# ***Interactive comment on “Development of the very long range muographic imaging technique to explore the internal structure of an erupting volcano, Shinmoe-dake, Japan” by T. Kusagaya and H. K. M. Tanaka***

**T. Kusagaya and H. K. M. Tanaka**

Received and published: 22 September 2015

Fig. 1.

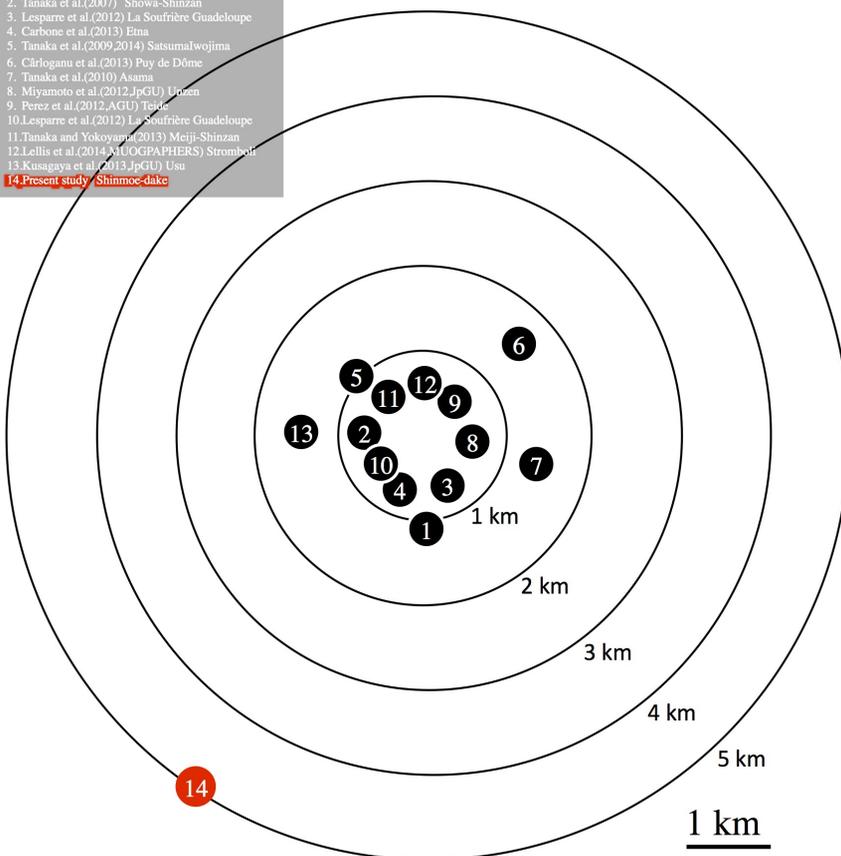
2. Page 3 line 43, Fig. 1 should be simplified by removing presently used volcano plane-map as a background.

→Fixed. Please see Fig. 1.

Fig. 2.

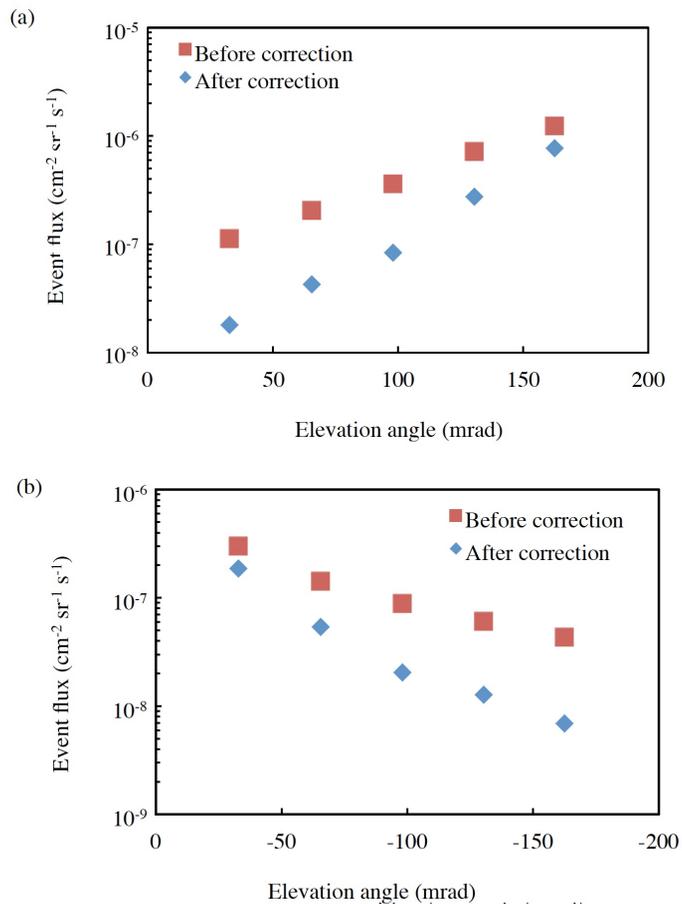
7. Page 47 Fig. 13 (b), Elevation angle (mrad) of horizontal axis should be negative values like -50, -100, etc.

→Fixed. Please see Fig.2.
